Global Change Notification (GCN)

Product Family MXP120 sealed 10663118

Series 34900 December 10, 2014

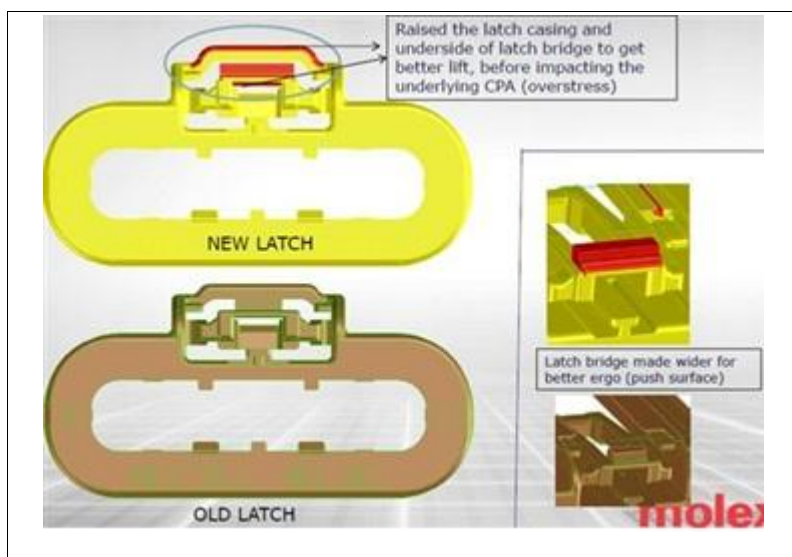
Change Description To improve connector un-mating ergonomics, we are implementing a different latch design on our receptacle connectors . The change has been already implemented on the 1x4 and needs to be implemented on the 1x6 as they share the same assembly equipment. Change will be implemented on 1x2 and 1x3 as well to be consistent in performance and features across the family. This change has been reviewed and approved by the OEM and immediate implementation has been requested.
